ITEM FOR ENVIRONMENTAL BOARD AGENDA

**NAME & NUMBER
OF PROJECT:** OVERLOOK AT SPICEWOOD SPRINGS
SPC-2015-0317C

REQUEST: Variance request is as follows:
To reduce the Critical Environmental Feature (CEF) buffers
of 2 canyon rimrocks (RR-1 and RR-2) from the standard
150-foot distance; the proposed buffer width for RR-1 is 50
feet and for RR-2 is 106 feet.
LDC 25-8-281(C)(1)(a)

SUBJECT: Overlook at Spicewood Springs
Case No. SPC-2015-0317C

TOPOGRAPHIC MAP - EXISTING CEF BUFFER

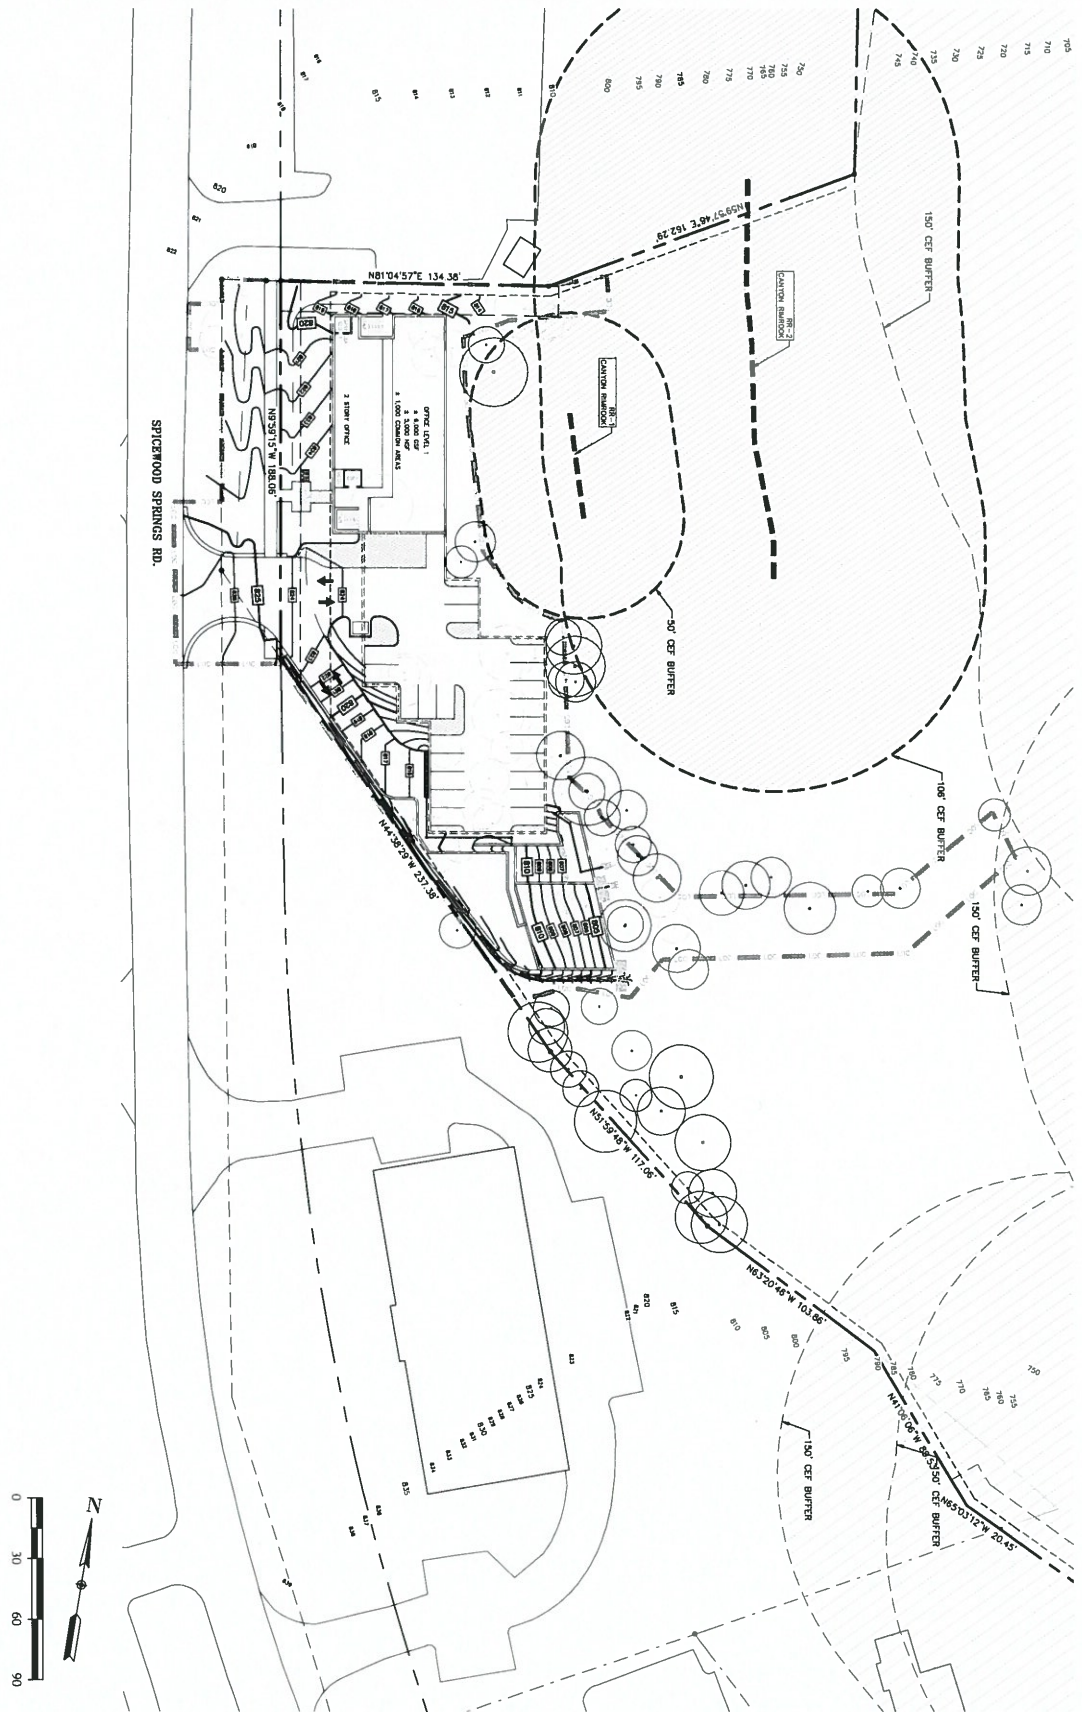
The building footprint was designed to maximize the CEF setbacks to the greatest extent feasible. A 150-foot setback for RR-1 would extend to the right of way of Spicewood Springs Road, rendering the site undevelopable.

Attached is an exhibit showing the proposed CEF setbacks for RR-1 and RR-2, reduced to 50 feet for RR-1 and 106 feet for RR-2. Also attached is an exhibit showing 150-foot setbacks for both, indicating that the site is rendered undevelopable without the requested setbacks.

Overlook at Spicewood Springs, Case No. SPC-2015-0317C Critical Environmental Features near proposed building

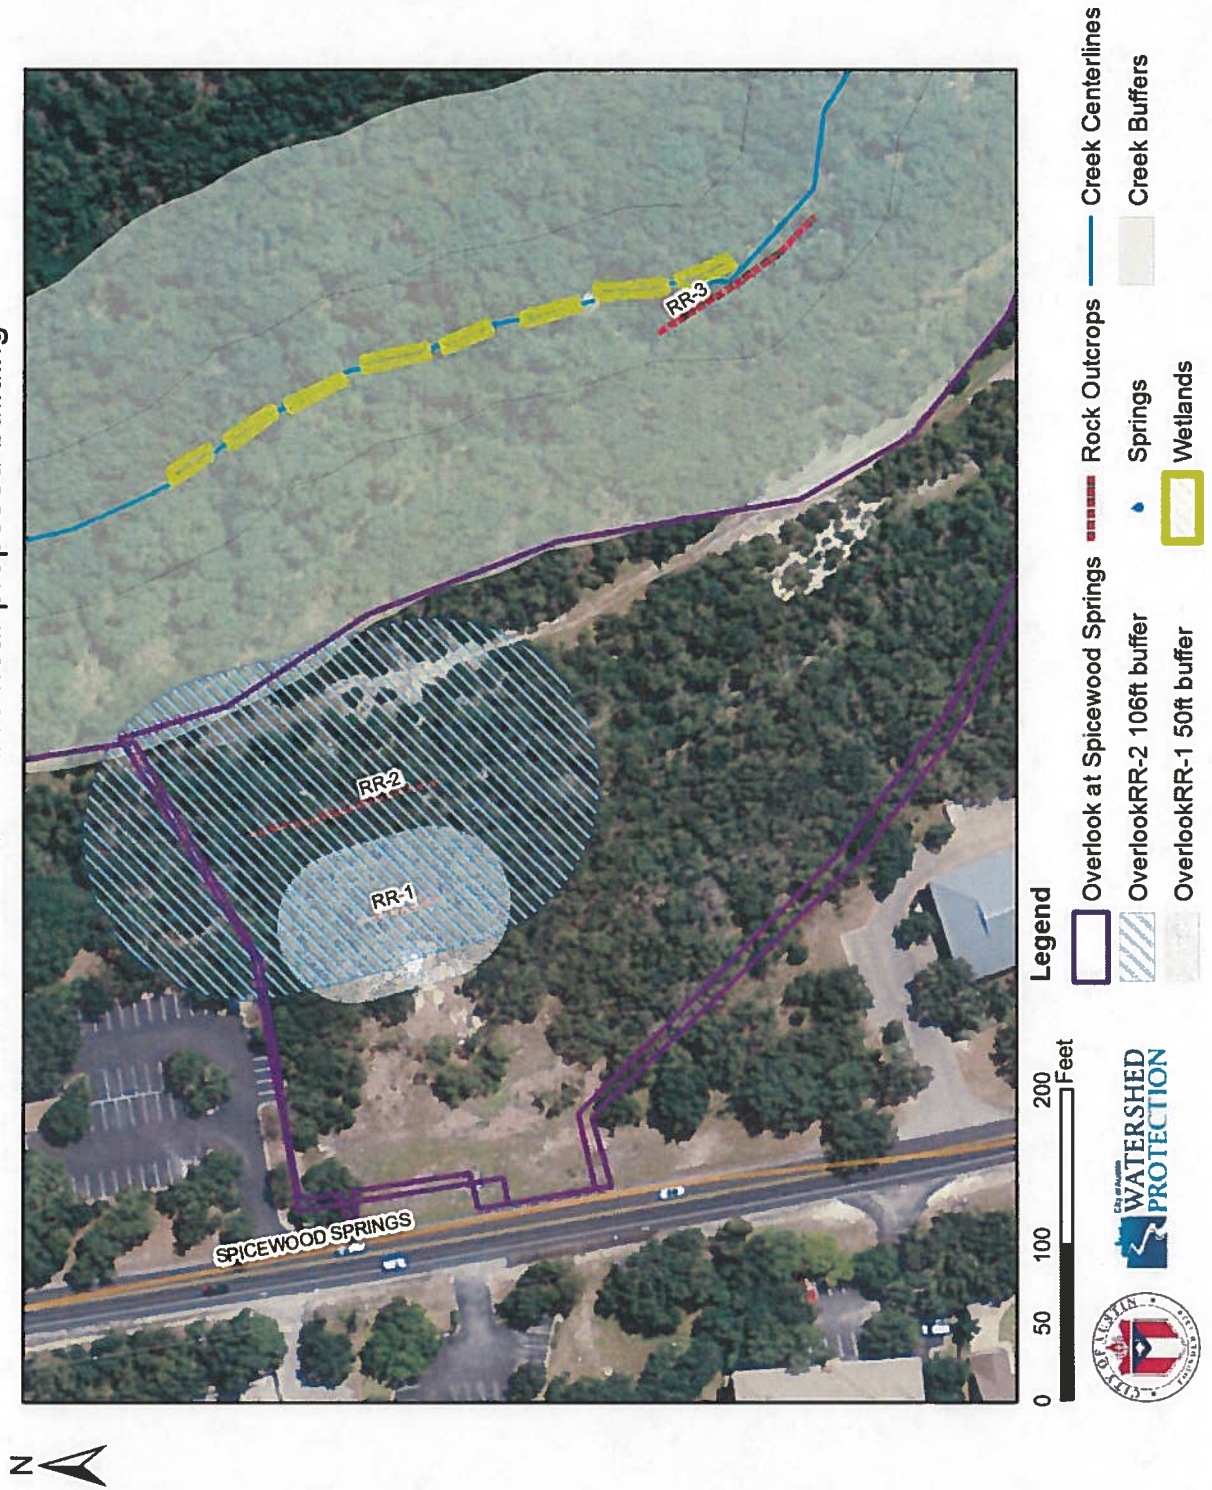
However, canyon rimrock RR-2 does not meet the criteria due to slopes that are greater than 15% that are located downslope of canyon rimrock RR-1 and upgradient of RR-2. The applicant chose to combine the variance request to reduce the CEF buffer of RR-1 with the Land Use Commission variance request to reduce the CEF buffer of RR-2 rather than request an administrative review. For this reason, the Environmental Commission and the Zoning and Platting Commission are evaluating this combined variance request.

Exhibit 5 - Proposed Construction Overall View

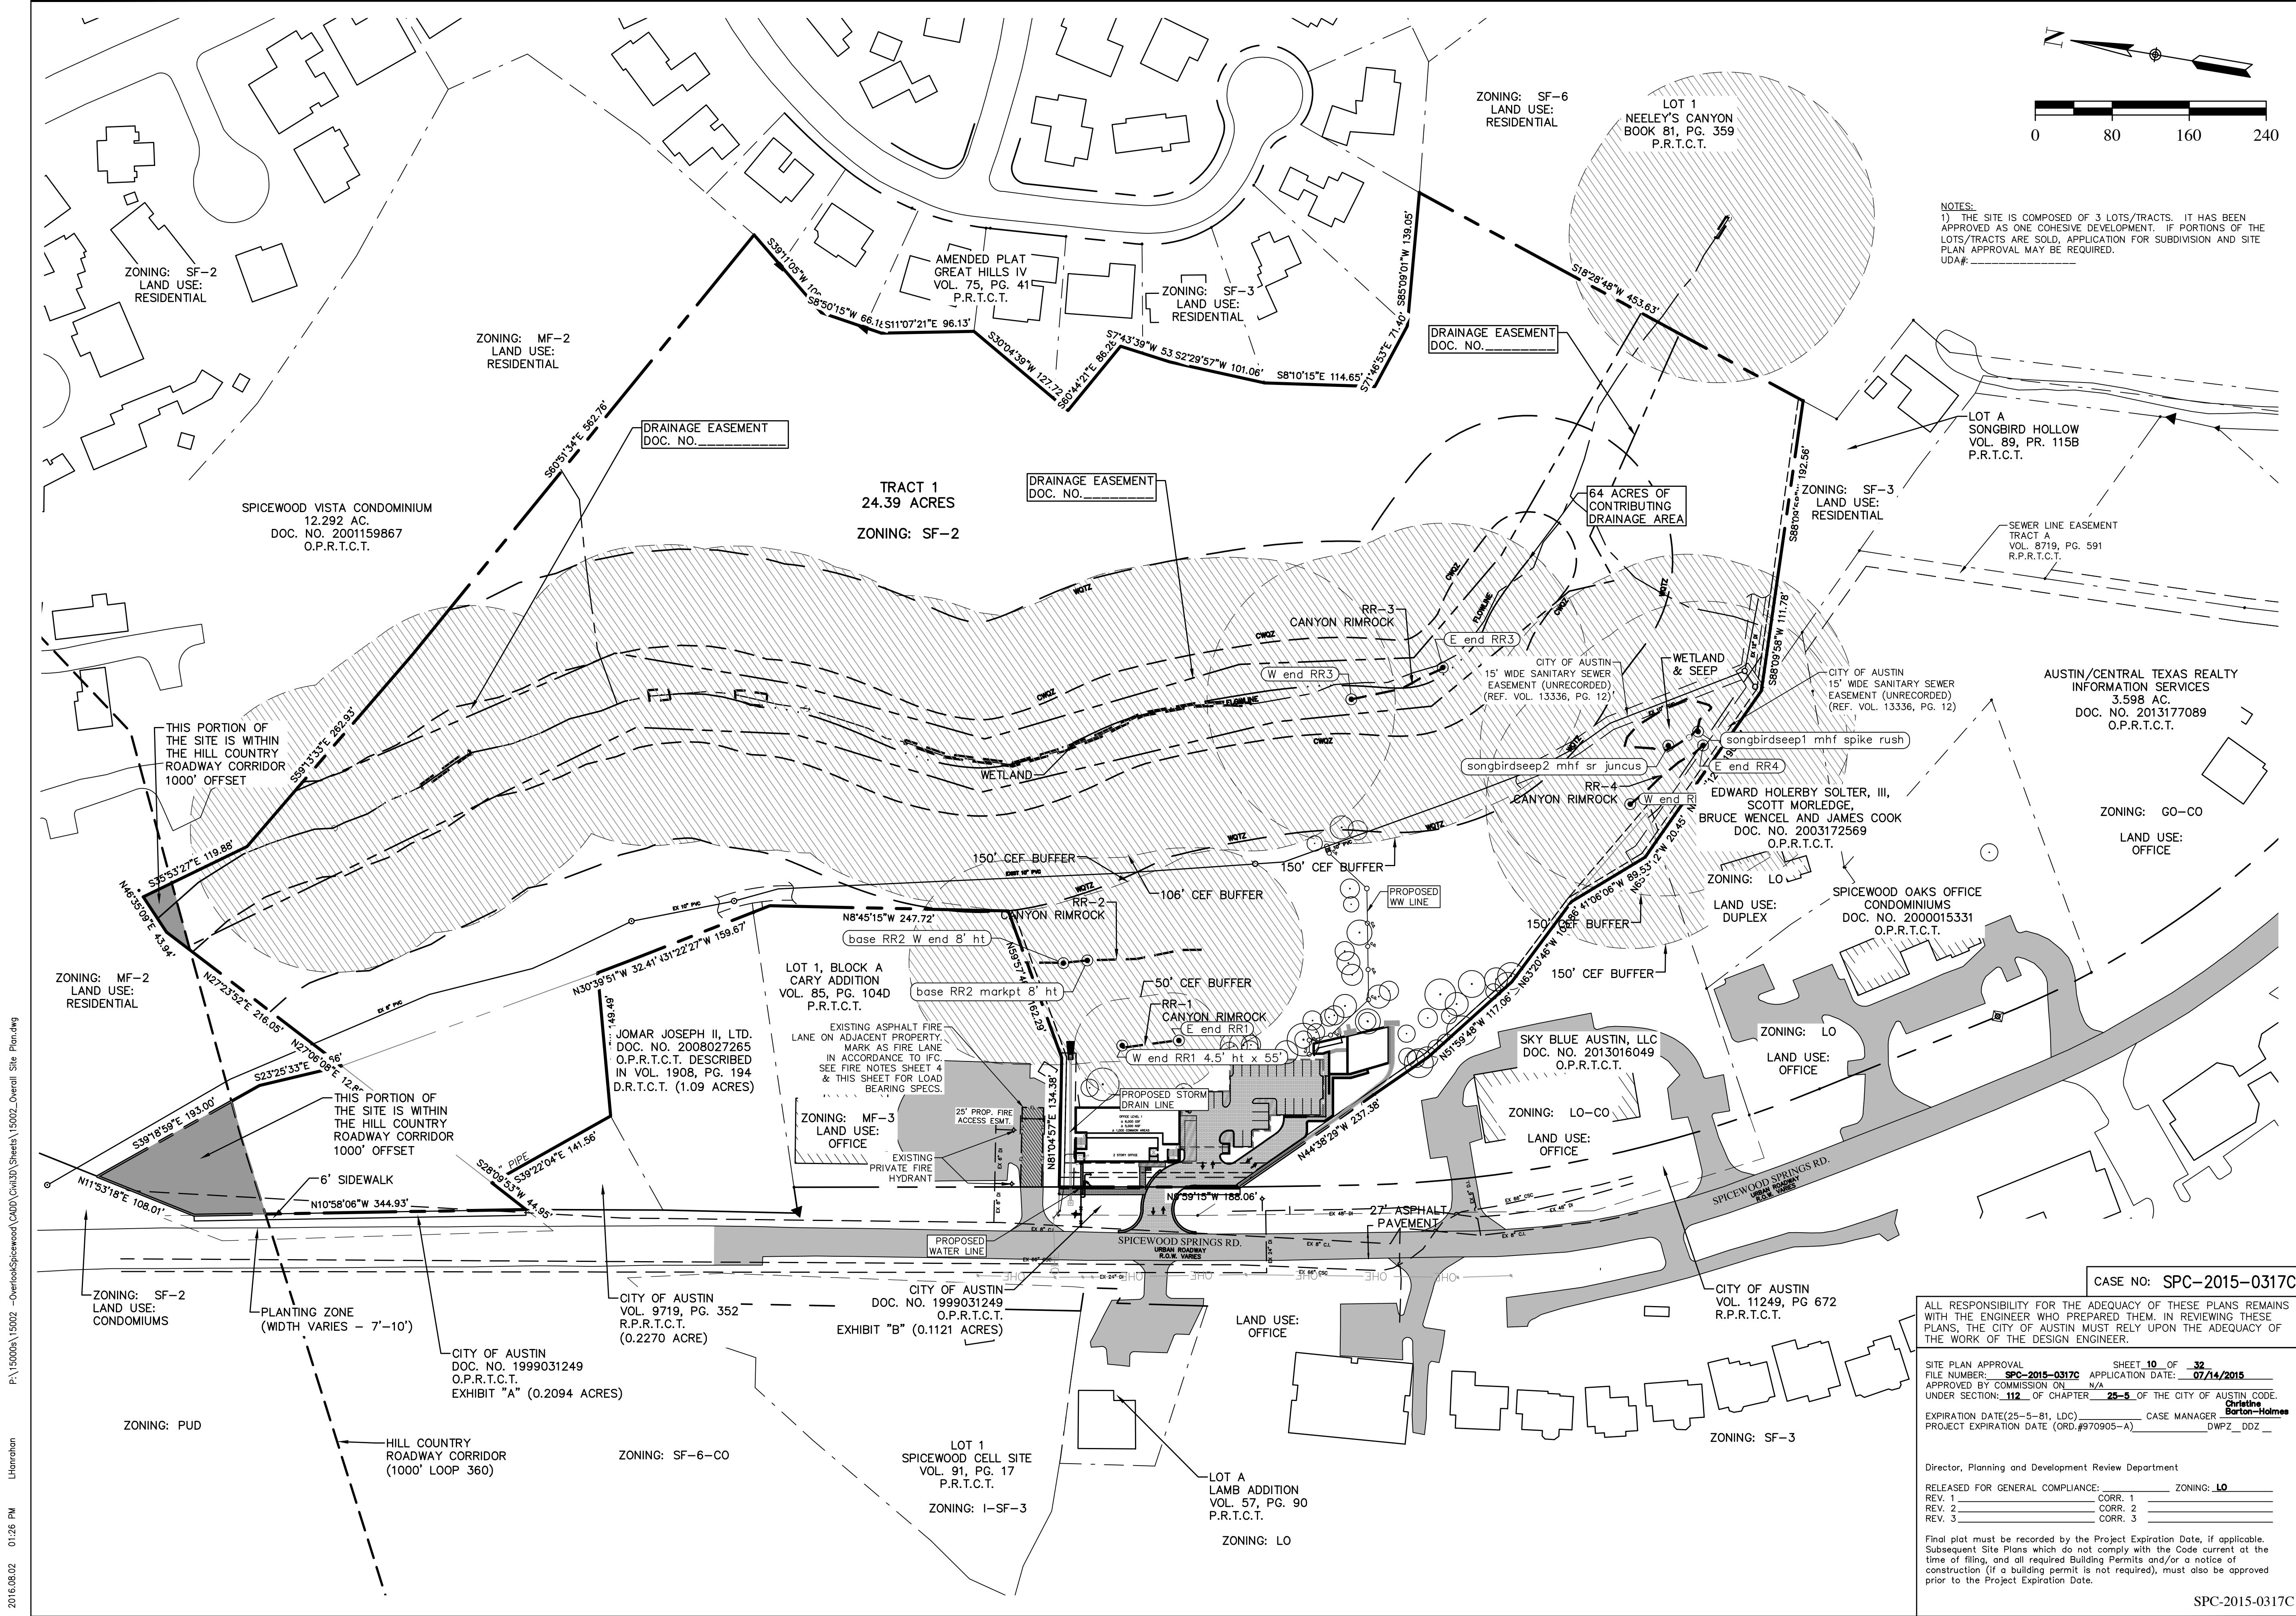
- To reduce the buffer for canyon rimrock number RR-1 to 50 feet; and
- To reduce the buffer for canyon rimrock number RR-2 to 106 feet.

(Exhibit 5 – Proposed Construction Overall View and Exhibit 7 – CEF Map)

The applicant will provide “Jersey” barriers in addition to silt fence along the downslope portion of the Limit of Construction. This will offer structural reinforcement to silt fence; silt fence will reduce transport of sediment beyond the Limit of Construction. Also, mulch logs will be placed downslope of the “Jersey” barrier in the area upslope of canyon rimrock RR-1 as an additional measure to capture sediment.

1. Install additional temporary erosion and sedimentation control measures at the upslope perimeter of a 50-foot CEF buffer for canyon rimrock CEF RR-1. These measures include "Jersey" barriers and mulch socks placed downslope of the "Jersey" barriers.

EXHIBIT 7 - CEF Map

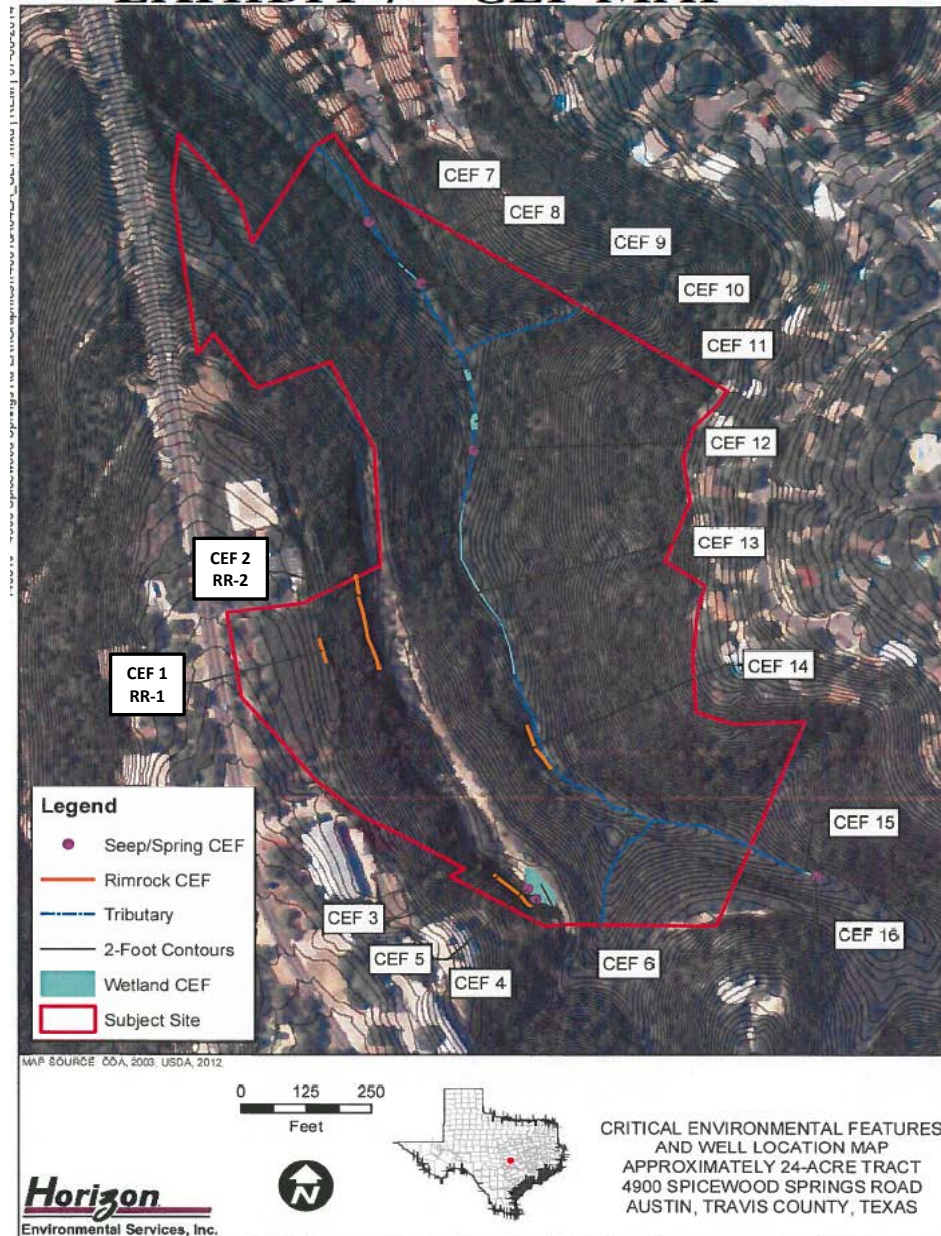
Two of the sixteen CEFs are the subject of this variance request. Canyon rimrock RR-1 is 5 feet in height and 52 feet in length. This outcrop is at the base of the Dolomitic member of the Edwards Group and is considered the edge of the Recharge Zone, at this location. Canyon rimrock RR-2 is 8 to 10 feet in height and 200 feet in length and is within the Walnut Formation.
